# ***Corrections to***

**Information technology—  
Telecommunications and information exchange between systems—  
Local and metropolitan area networks—Specific requirements—**

## **Part 3: Carrier sense multiple access with collision detection (CSMA/CD) access method and physical layer specifications**

Correction Sheet

**Figure 2-2—Service specification primitive relationships  
(optional MAC control sublayer implemented)**

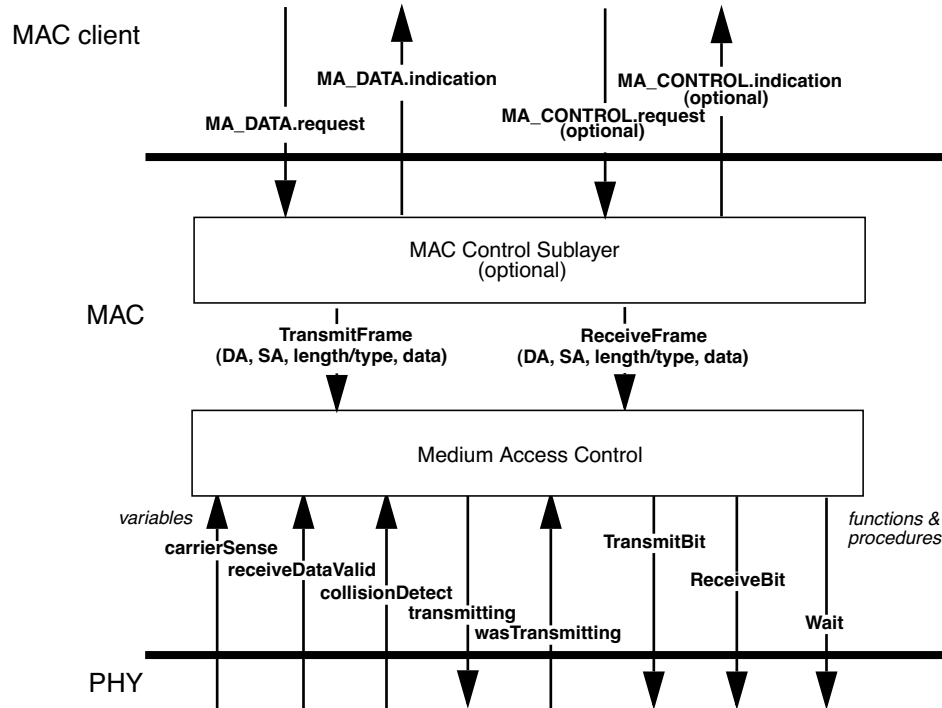
**Page 34:** Figure 2-2.

Replace Figure 2-2 with the following figure.

NOTE—The deletion of the wasTransmitting arrow, restored by the above, has been proposed by an IEEE P802.3 Revision Request, (URL - [http://www.ieee802.org/3/maint/requests/maint\\_1021.pdf](http://www.ieee802.org/3/maint/requests/maint_1021.pdf)) which is currently being balloted as part of IEEE P802.3ag Maintenance Ballot #6. This was published in IEEE Std 802.3, 2000 Edition in error.
